# DEVELOPMENT REVIEW BOARD REPORT

ITEM NO. 8

SUBJECT **Wildcat Hill  
8-PP-2005**

REQUEST Request to approve a Preliminary Plat with amended development standards for a 76-lot custom home subdivision on a 360-acre parcel.

143-PA-2004

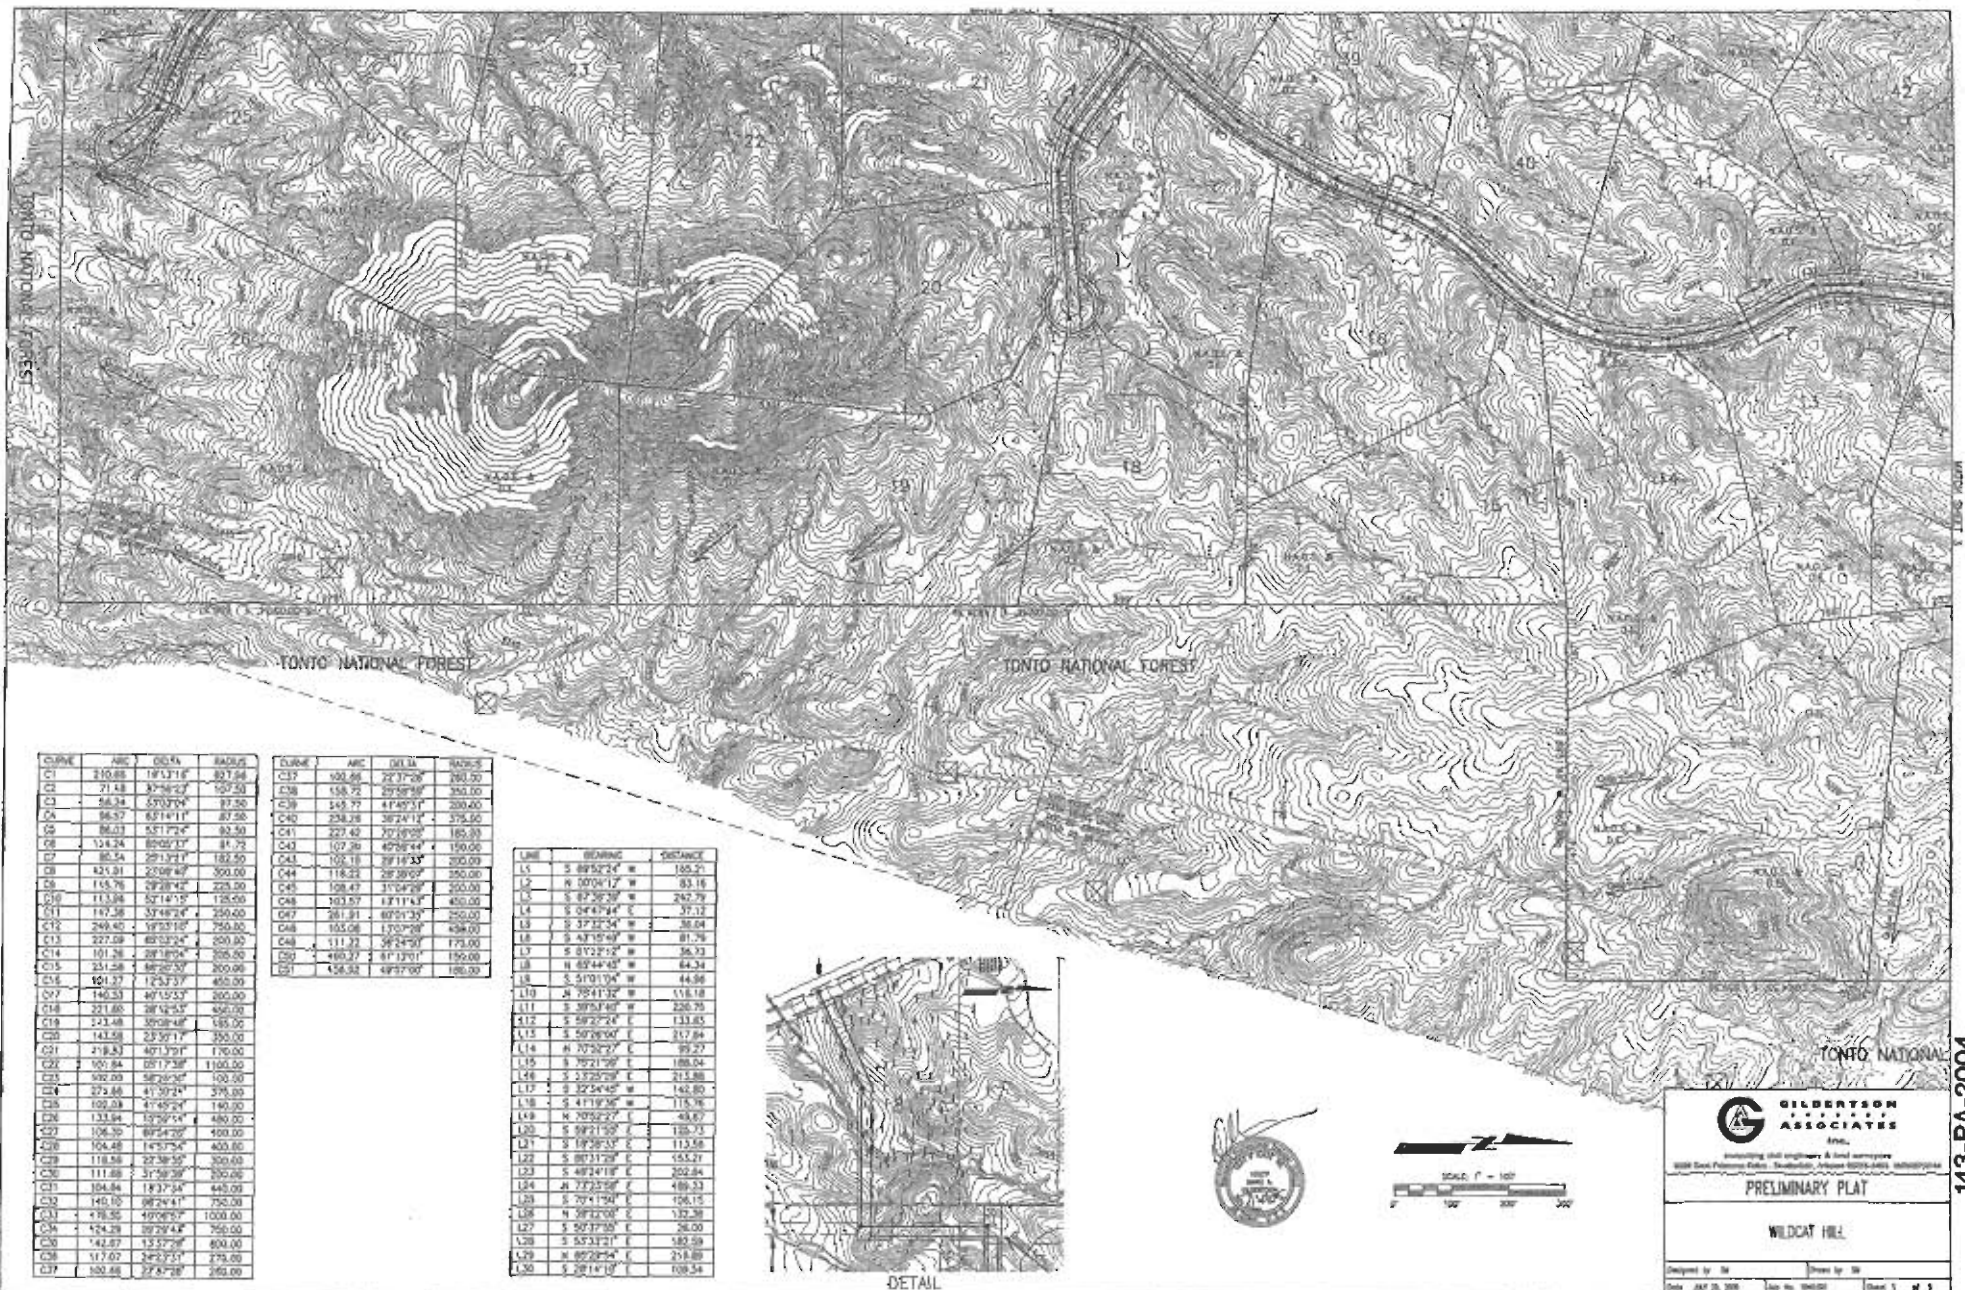
12. For the subdivision entry design, the ingress and egress lanes shall be placed closer to each other.
13. Provide emergency access connection at Carefree Highway between lots 58 and 59.
14. Exception lots (not part of this subdivision) shall have right-of-way or private street tract frontage. The developer shall provide such access and shall include this with the final plat of this subdivision.
15. The developer shall construct and dedicate a turn-around at end of the exception lots access. The access to these lots shall be 20 feet minimum width.
16. For lot driveways over 200 feet need turn around area on lot. For driveways over 300 feet need passing area on driveway for fire truck. See Fire staff for more information.

66. Where a gated entrance is proposed, the developer shall design and construct the gated entrance in conformance with Figure 8.1-1 of the City's Design Standards and Policies Manual. The entry design should make ingress and egress lanes closer than shown in preliminary plans submitted to the City of Scottsdale.
